SUBSURFACE WASTEWATER DISPOSAL SYSTEM APPLICATION

PROPERTY LOCATION		>> CAUTION: LPI APPROVAL REQUIRED <<	
City, Town, or Plantation	Portland	Town/City	Portland
Street or Road	12 Cranston Street	Permit #	2012 65559
Subdivision, Lot #		Date Permit Issued	11/10/12
OWNER/APPLICANT INFORMATION		Fee: \$	Double Fee Charged []
Name (last, first, MI)	Kevin McGuire	Local Plumbing Inspector Signature	
Mailing Address of Owner/Applicant	12 Cranston Street Portland, 04103	L.P.I. # 1081	
Daytime Tel. #	838-8136	Municipal Tax Map # _____ Lot # _____	
OWNER OR APPLICANT STATEMENT		CAUTION: INSPECTION REQUIRED	
I state and acknowledge that the information submitted is correct to the best of my knowledge and understand that any falsification is reason for the Department and/or Local Plumbing Inspector to deny a Permit.		I have inspected the installation authorized above and found it to be in compliance with the Subsurface Wastewater Disposal Rules Application.	
Signature of Owner or Applicant _____ Date _____		Local Plumbing Inspector Signature _____ (1st) date approved _____

Permit No: 201265559	Date Applied For: 12/10/2012	CBL: 169 B011001
--------------------------------	--	-------------------

SUBSURFACE WASTEWATER DISPOSAL PLAN

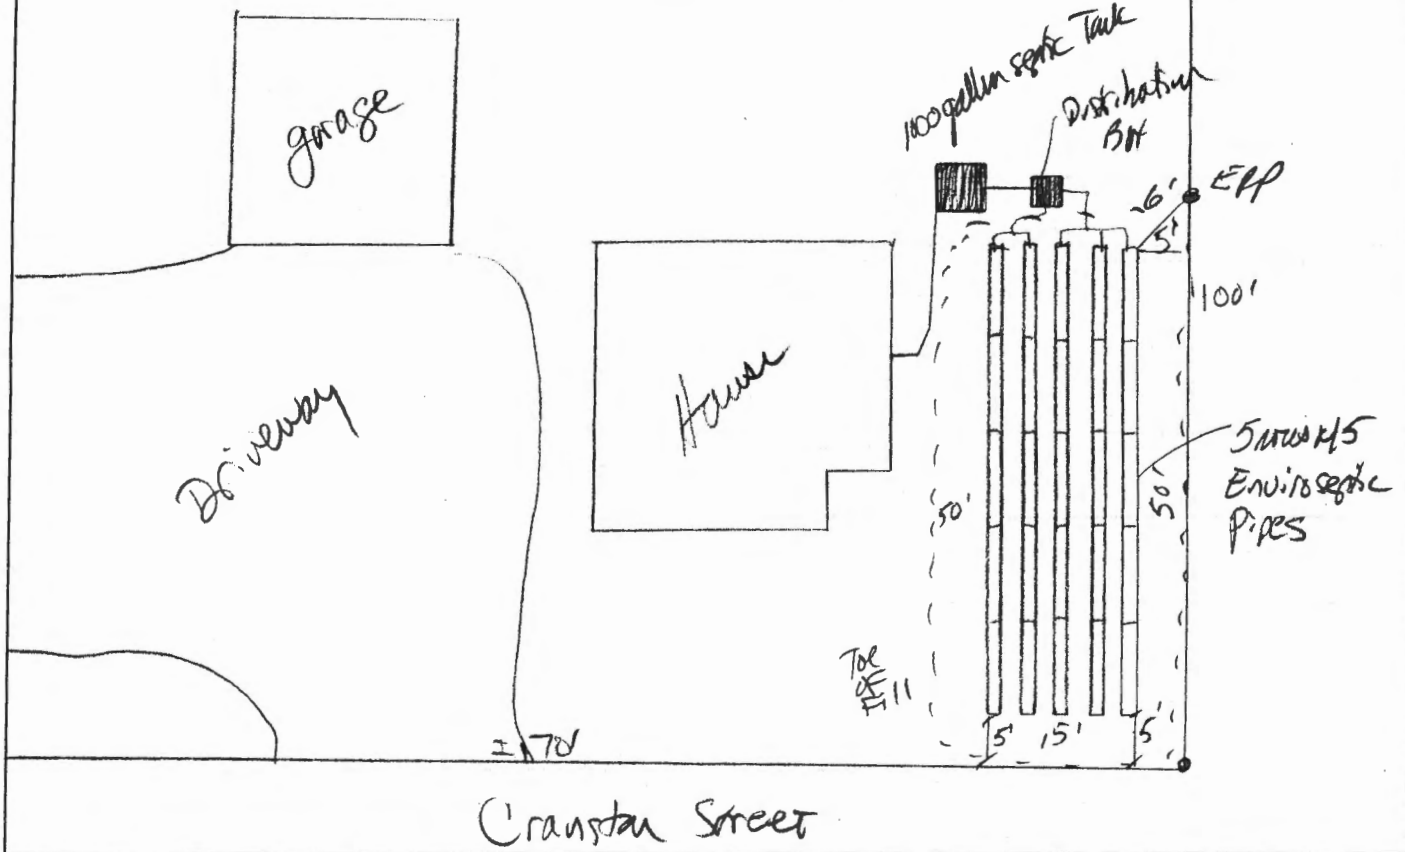
SPECIFIC VARIANCE REQUESTED (To be filled in by Site Evaluator. Use Additional Sheets, if needed.) SECTION OF RULE
1. Bed 10 feet from foundation Table 8A
2. Bed 5 feet from property line Table 8A
3. Tank 5 feet from house Table 8A
SITE EVALUATOR Well 60 feet from disposal bed and 70 feet from Tank Table 8A

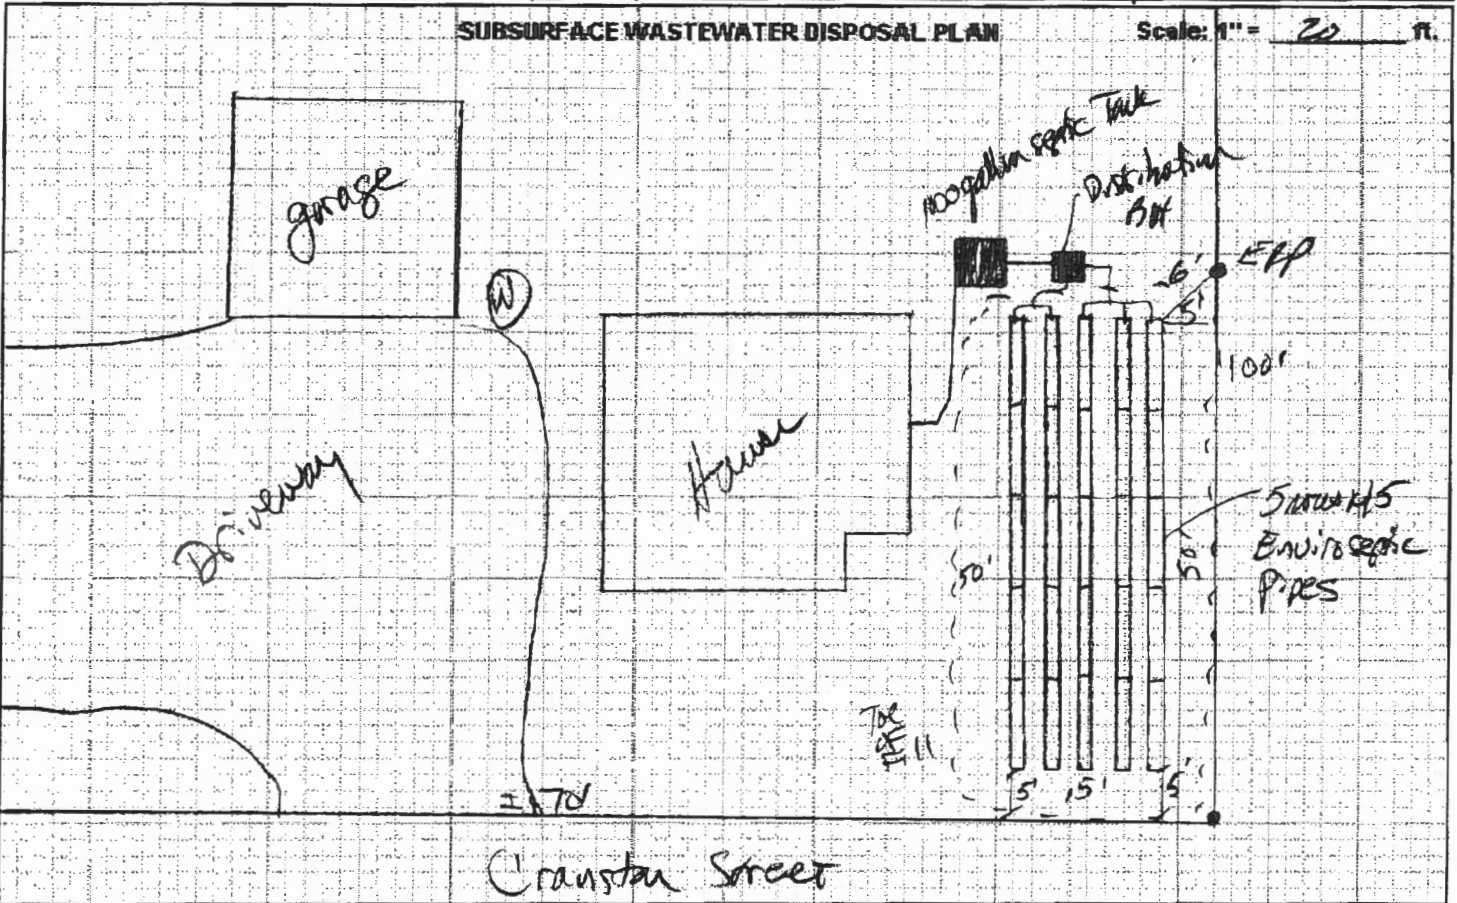
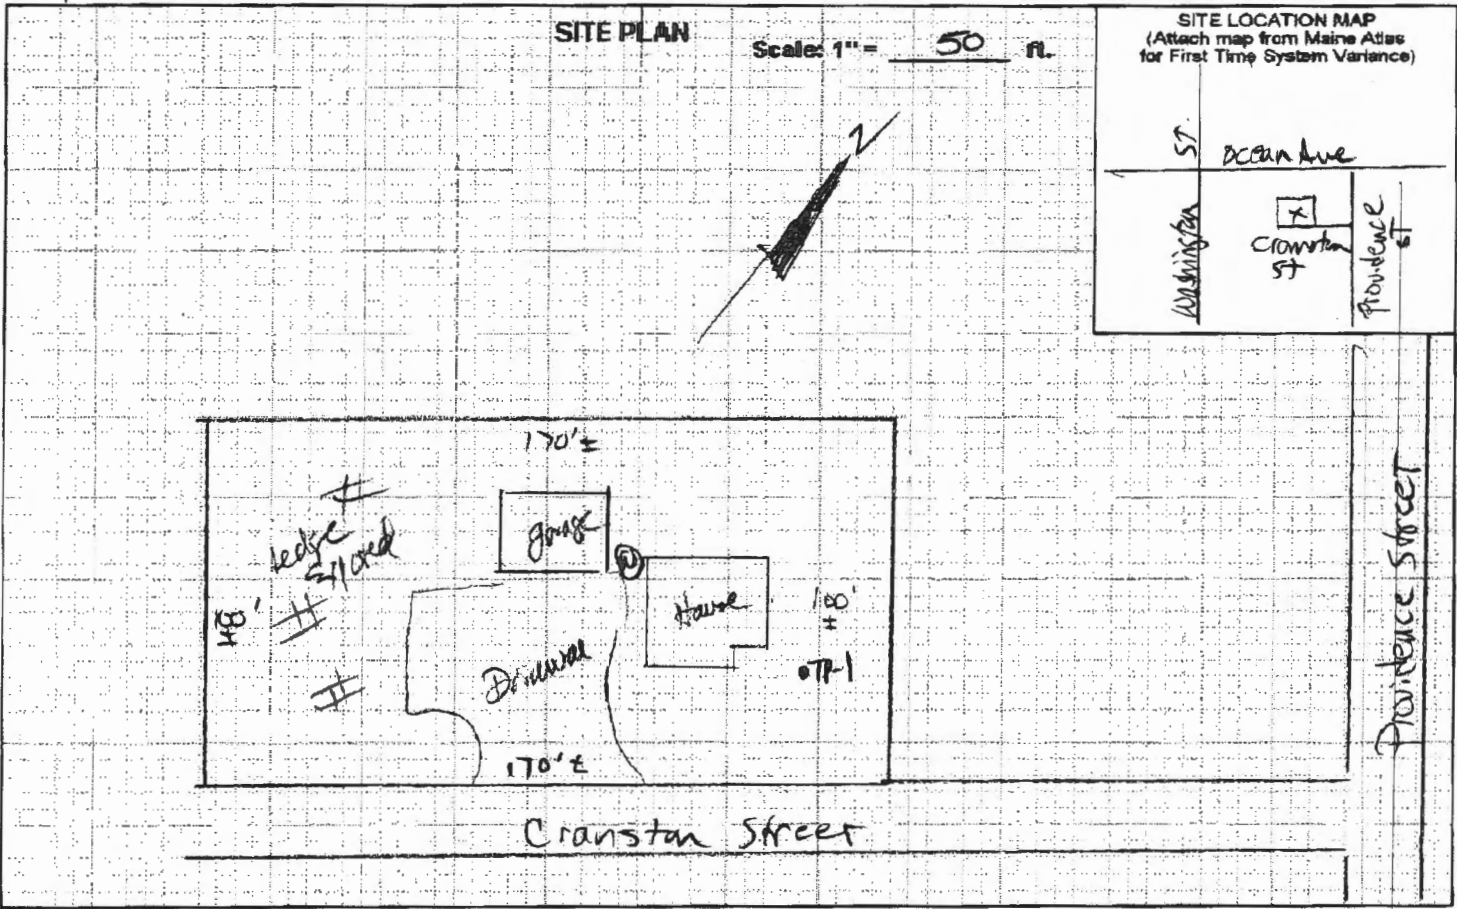
Dept: Building	Status: Approved w/Conditions	Reviewer: Jon Rioux	Approval Date: 01/08/2013
Note:	Ok to Issue: <input checked="" type="checkbox"/>		
1) Septic field and extension inspection for bottom preparation/ scarification to verify removal of vegetation, established transitional horizon and erosion and sedimentation control measures. Backfill inspection of septic field for approved materials, stabilization, slopes and extensions. Exposed septic field installation and tank location inspection to check elevations, dimensions, piping, plumbing station and system design prior to covering.
